DOCUMENT 009113 – ADDENDUM NO. 2

- A. Project Name: Optimist Pool Bathhouse Repair
- B. Owner: City of Raleigh, Recreation and Cultural Resources/Design Development Division
- C. Architect: Osterlund Architects, PLLC.
- D. Architect Project Number: 2325.
- E. Date of Addendum: 3-1-2024.

Optimist Pool Bathhouse Repair

INTERIOR ELEVATIONS-
WOMEN'S LOCKER ROOM

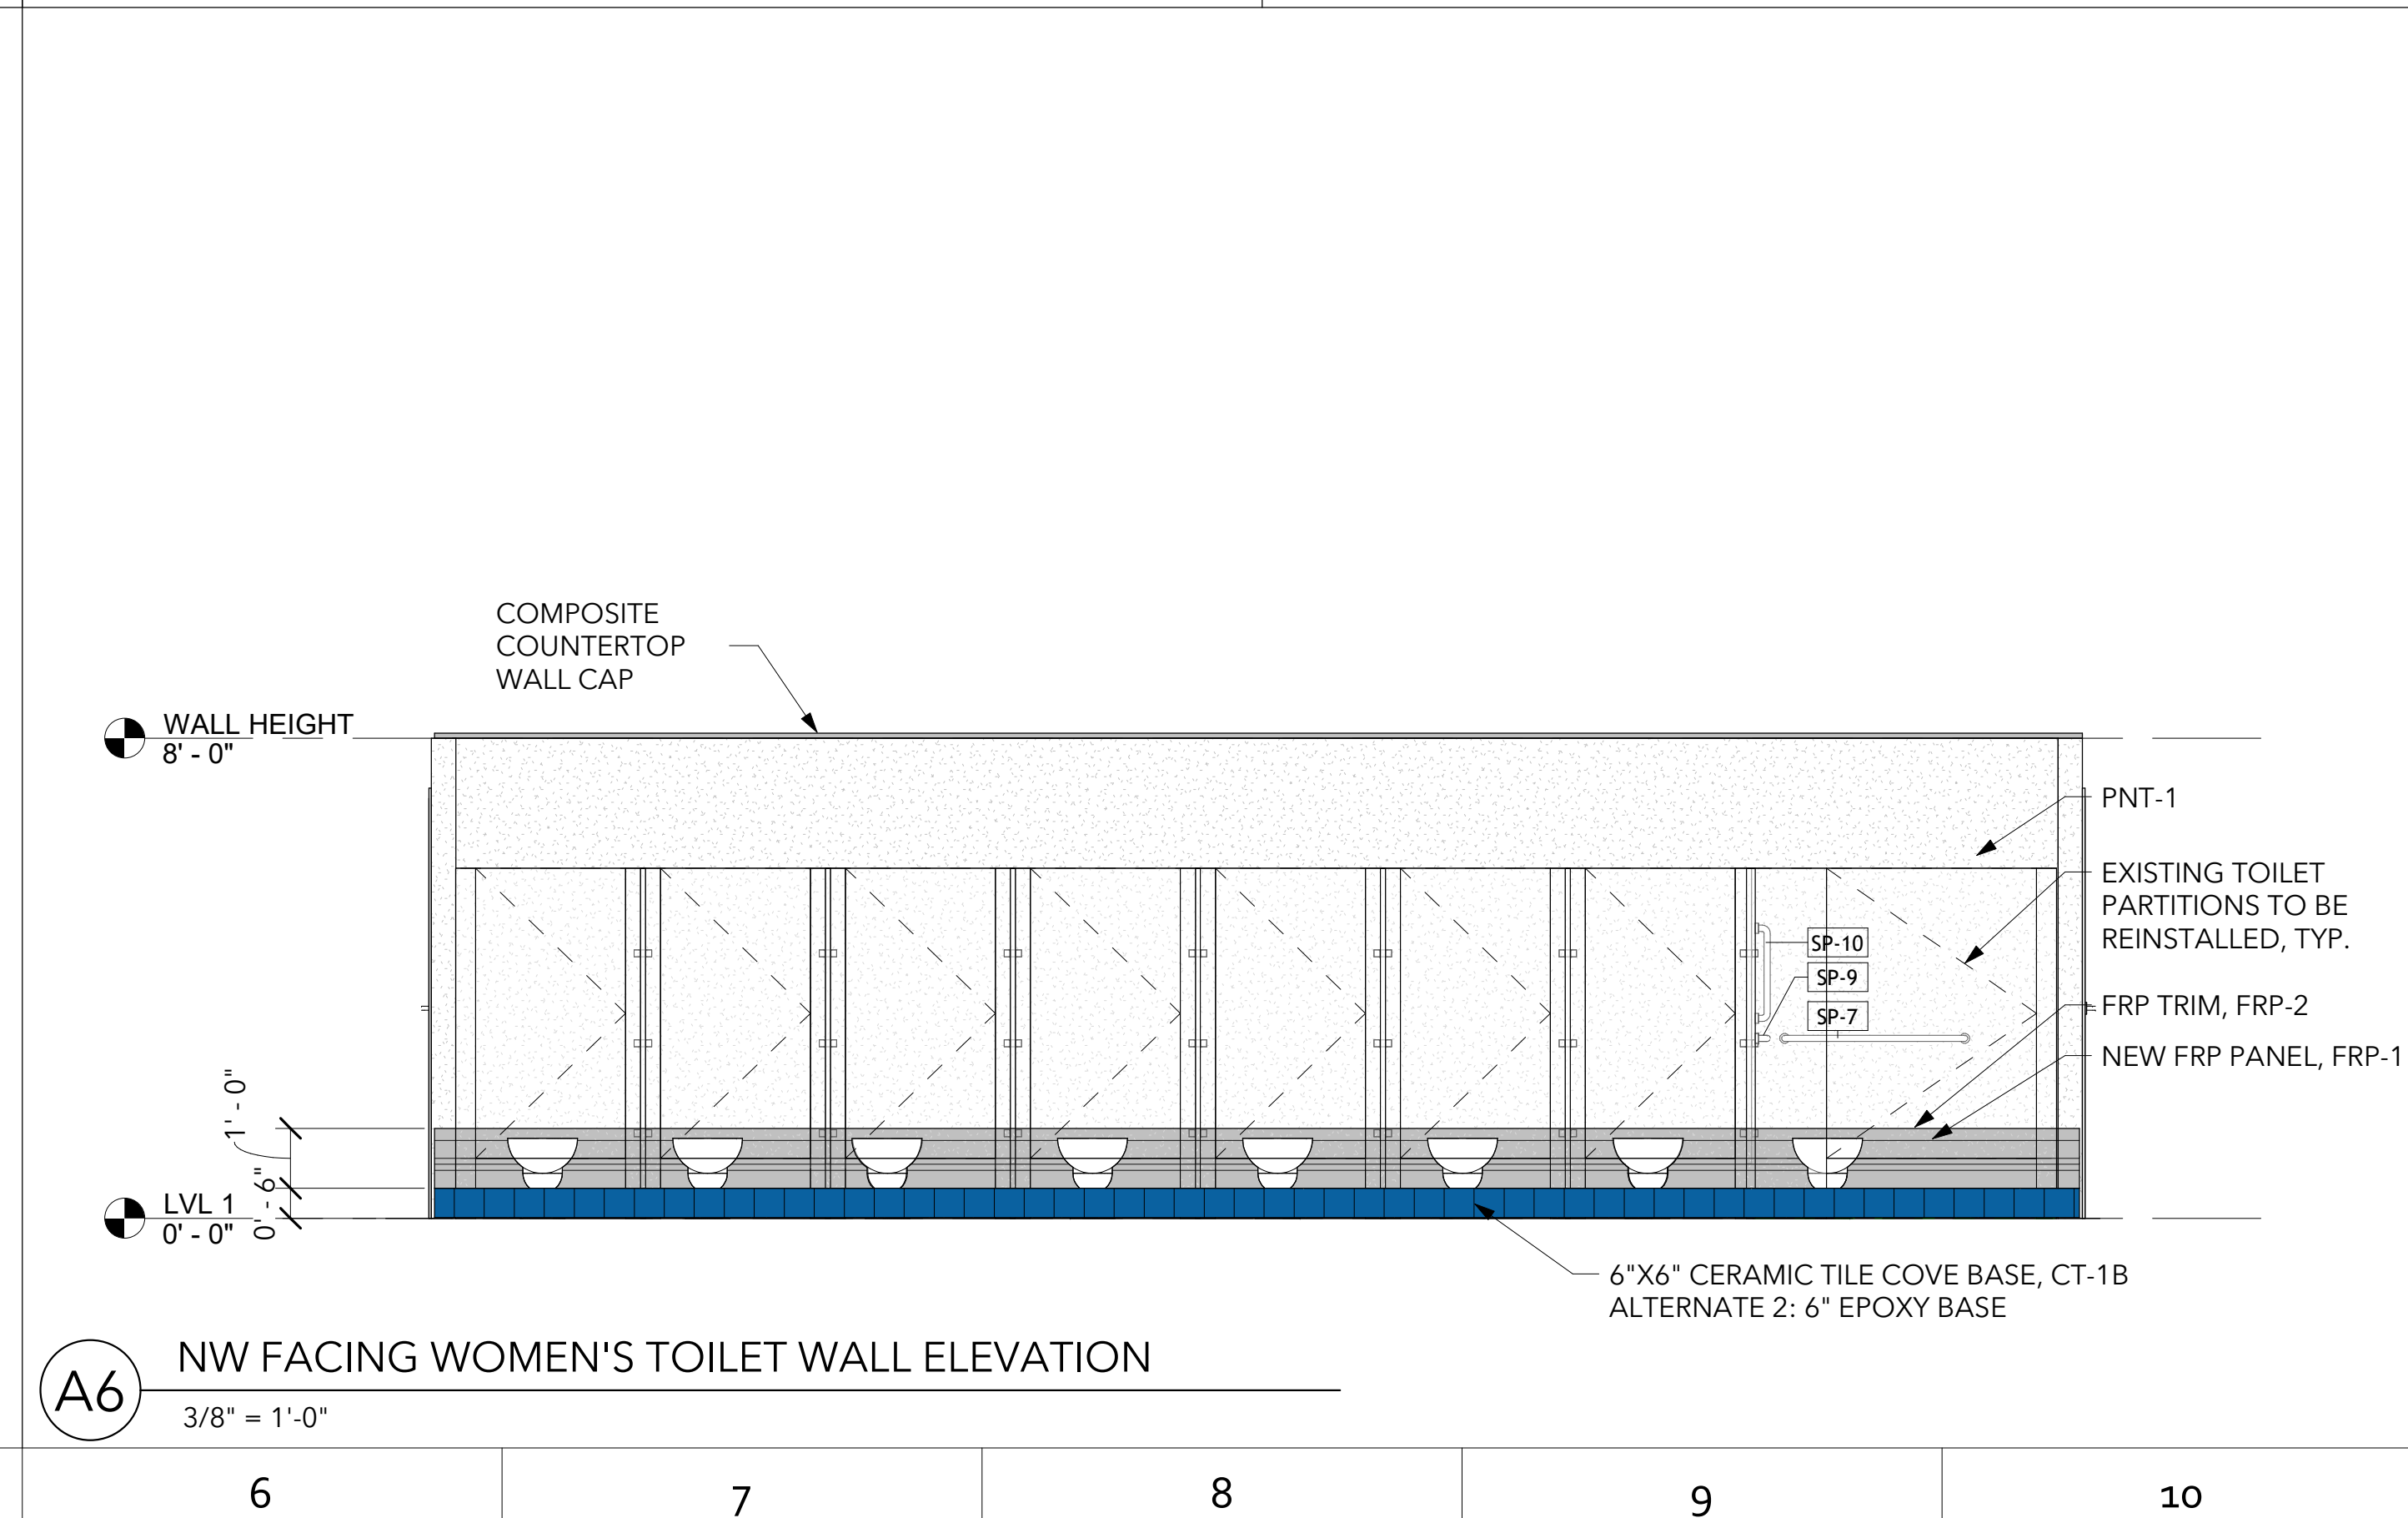
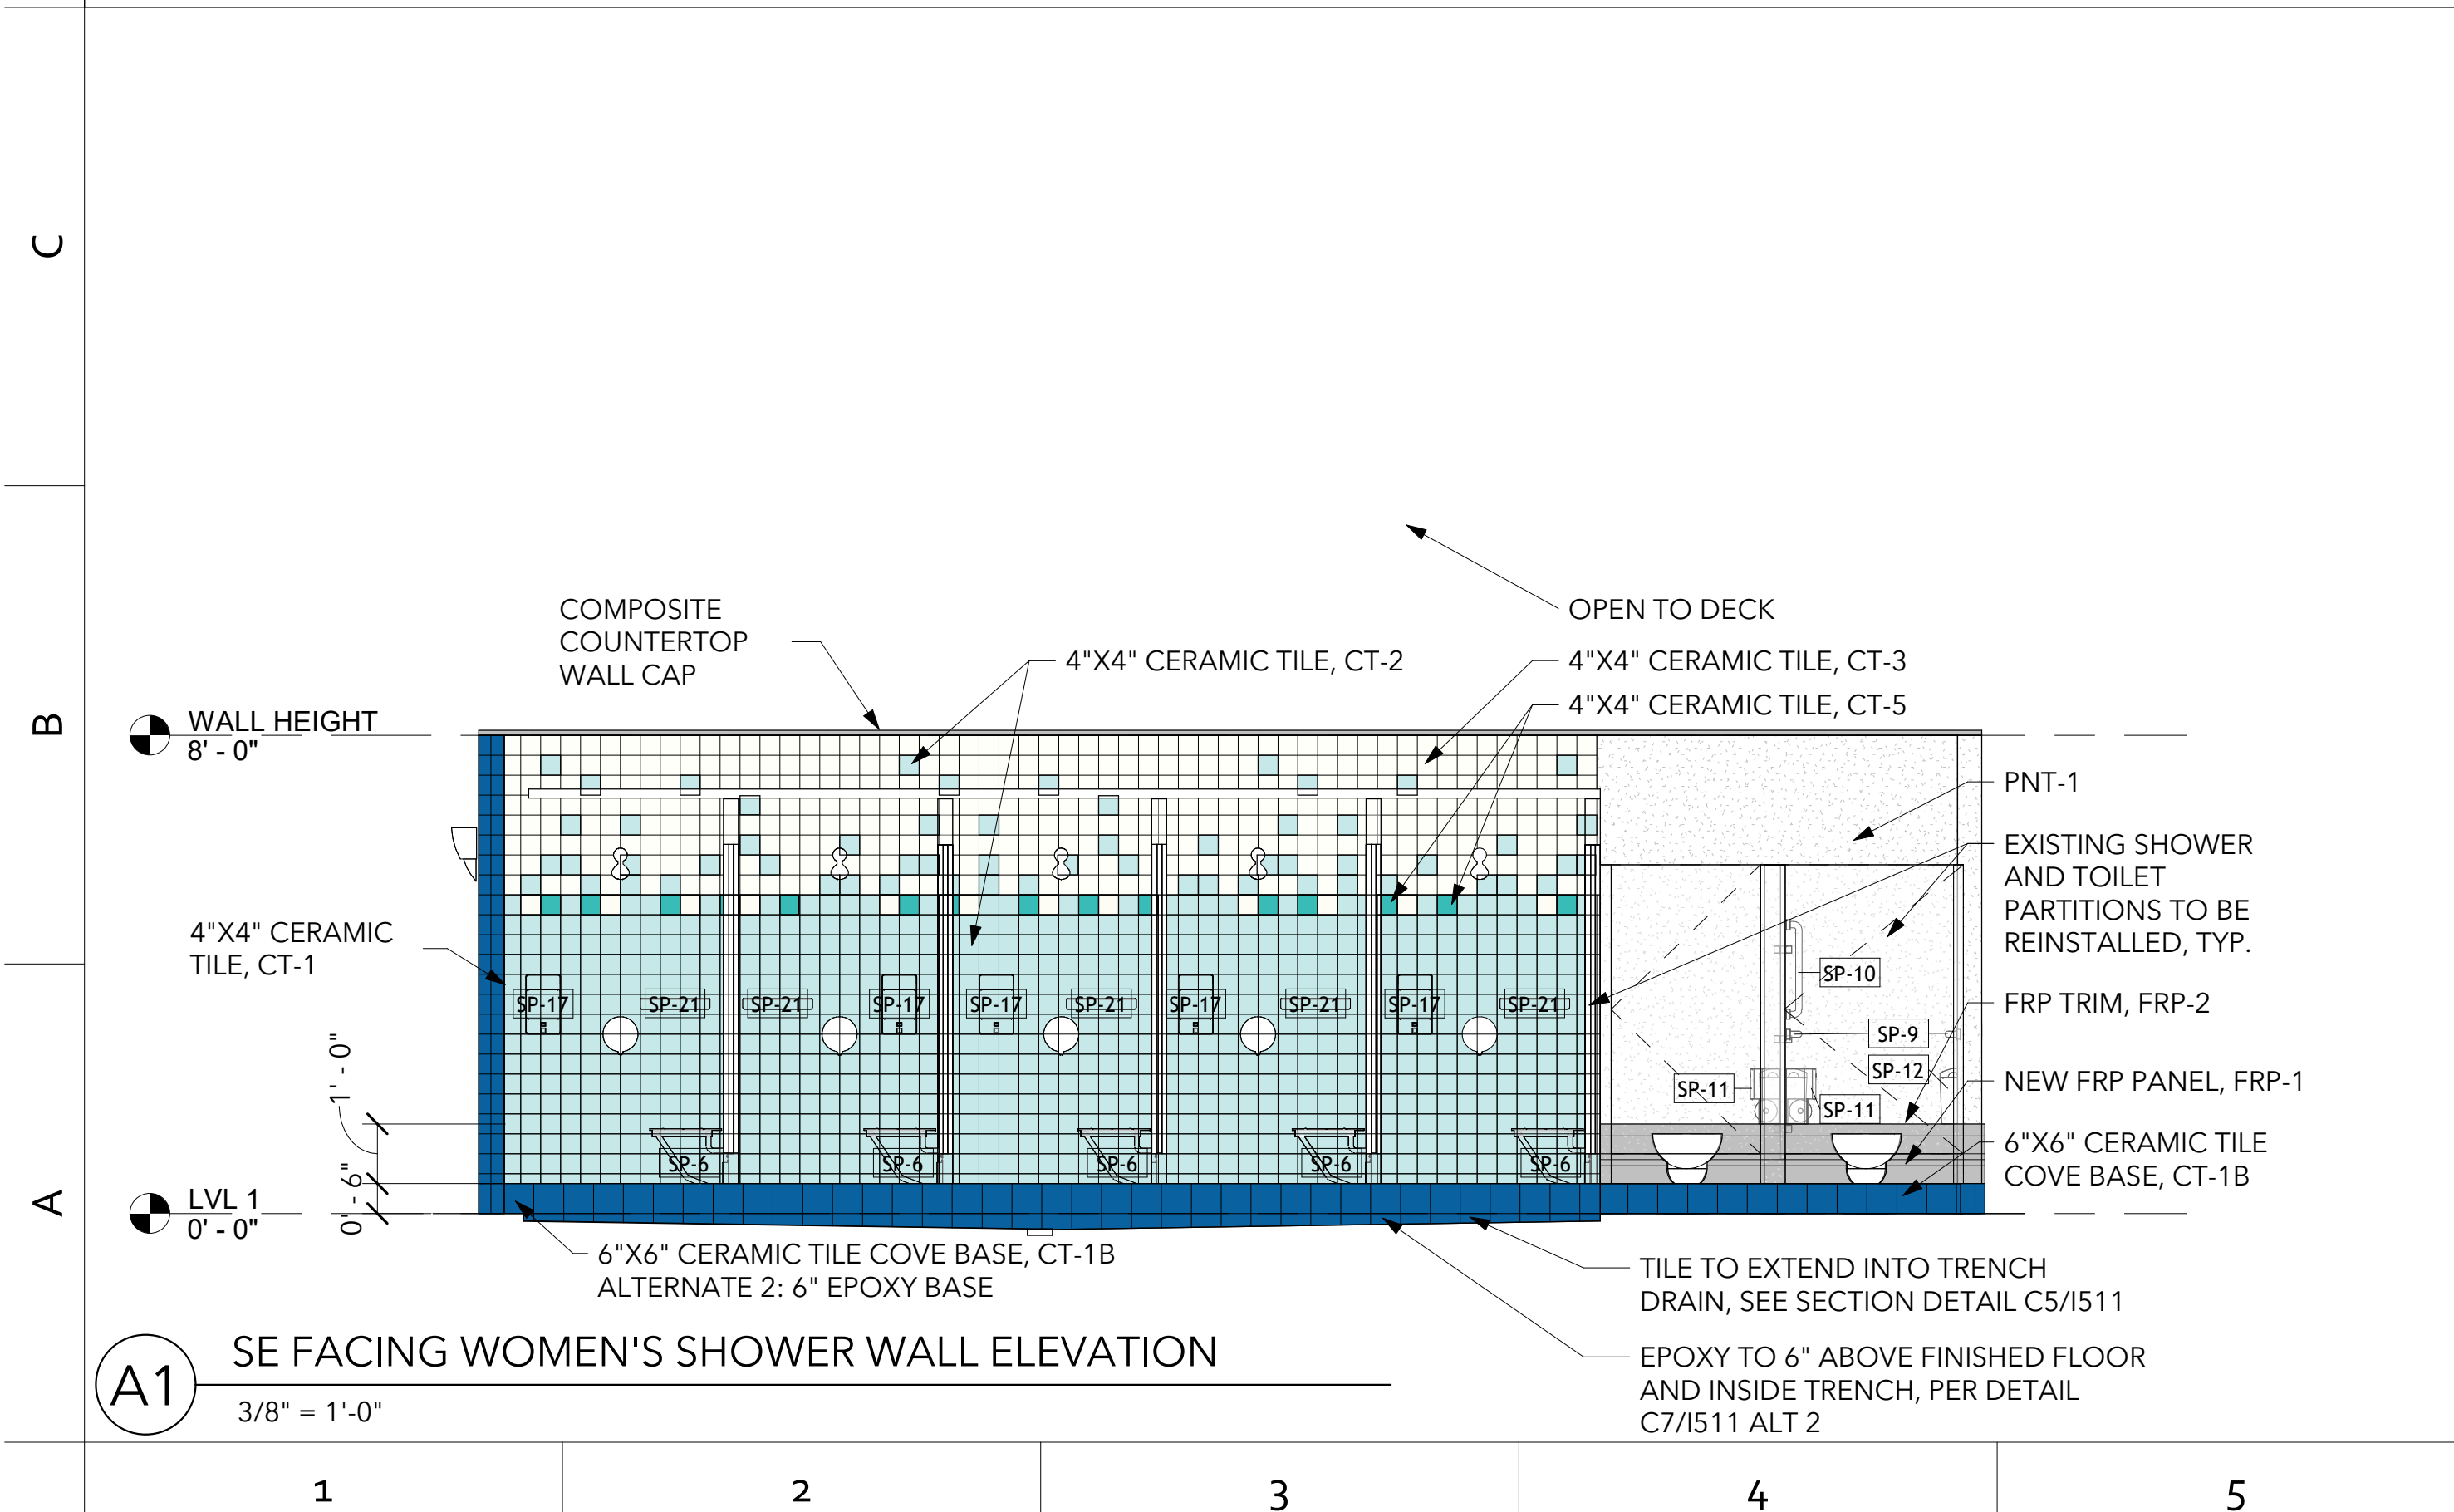
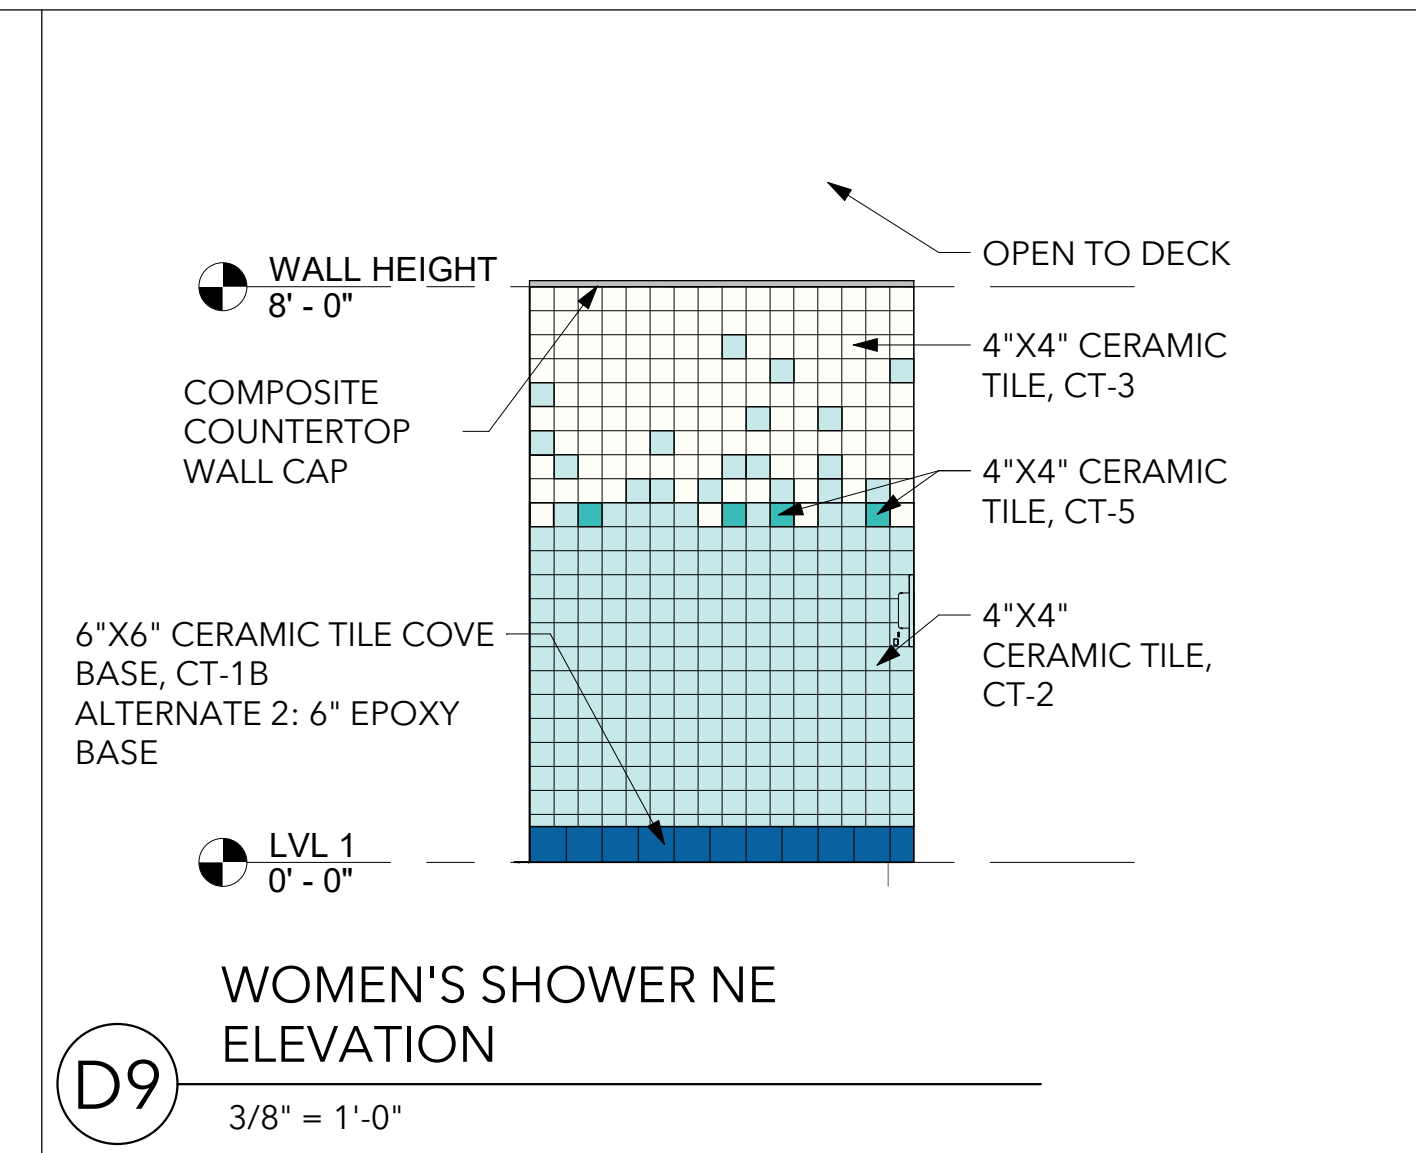
- A. This Addendum includes the following attached Documents and Specification Sections:
 - 1. Document 2325 Planholder List, dated 2-27-2024. (new)
 - 2. Document 2325 Bidder RFI Log, Dated 3-1-2024. (new)
 - 3. Document 2325 08 R2 I Sheets 03.01.24. (revised)
 - a. Revised Drawing D1-I201 to include all new mirrors instead of salvage and reinstall.
 - b. Revised Drawing A5- I204 to include all new mirrors instead of salvage and

RFI No.	Date Received	Via	Description	Response	Response Date	Addendum No.
1	2/19/2024	Email	I201 detail D1 and I 204 Detail A5 both have a note showing existing to be reinstalled pointing to SP-22 (mirrors)	Mirrors are all to be new, purchased and installed by GC.	2/22/2024	2
2	2/19/2024	Email	I 601 shows SP-22 Mirrors as new and by GC.	Mirrors are all to be new, purchased and installed by GC.	2/22/2024	2
3	2/19/2024	Email	Are mirrors to be removed and reinstalled per elevation or new per schedule?	Mirrors are all to be new, purchased and installed by GC.	2/22/2024	2
4	2/21/2024	Pre-Bid Meeting	Are Bid Bonds or P&P Bonds Required?	Bid Bond is required over \$500,000; P&P is required over \$300,000	2/21/2024	2
5	2/21/2024	Pre-Bid Meeting	Will Conex be required during construction?	Yes, Conex will be required. Hallway will be available for storage but only after June 13, 2024	2/21/2024	2
6	2/21/2024	Pre-Bid Meeting	What is the age of the building? Is asbestos a concern?	Building was built in 2008, no hazmat required.	2/21/2024	2
